Re: Botley West Solar farm project.

Errors in document EN010147-001239: Applicant's Change Request 2 Notification?

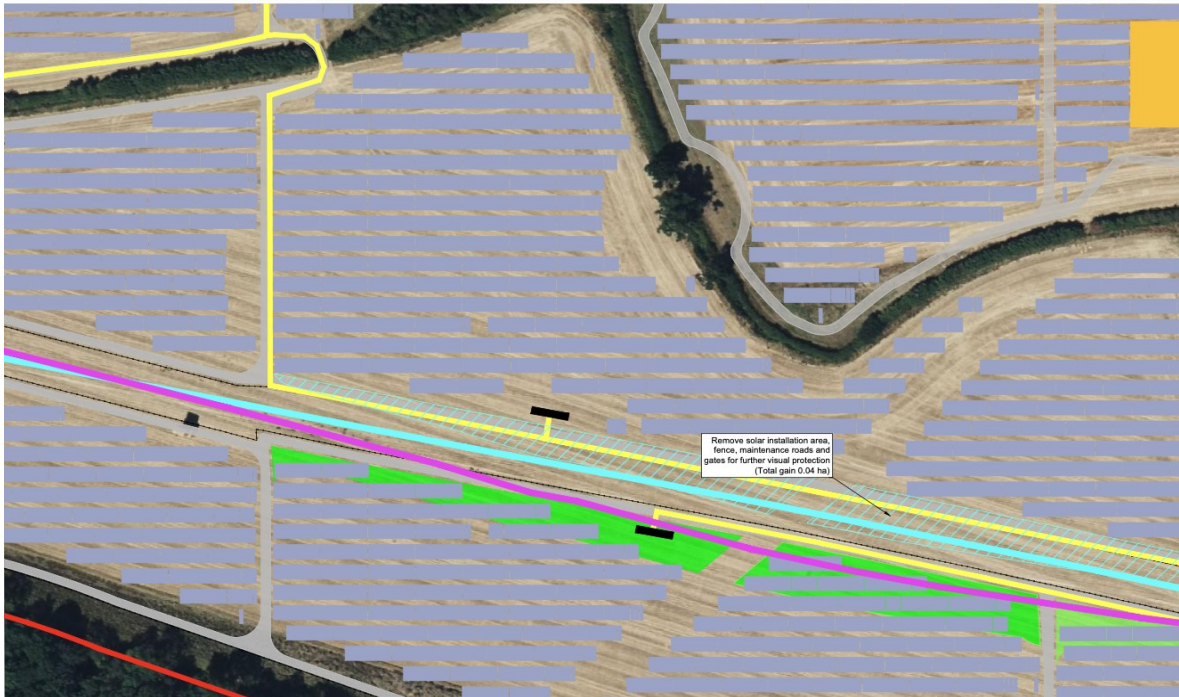
On Page 26 of EN010147-001239 (shown below), on the right hand side there is a map of the region under consideration depicted as a blue rectangle, and this blue rectangle encompasses Hall Farm Paddocks. However, the main figure bears no resemblance to the area depicted in the blue rectangle! In my opinion the map is completely incorrect or at best confusing?
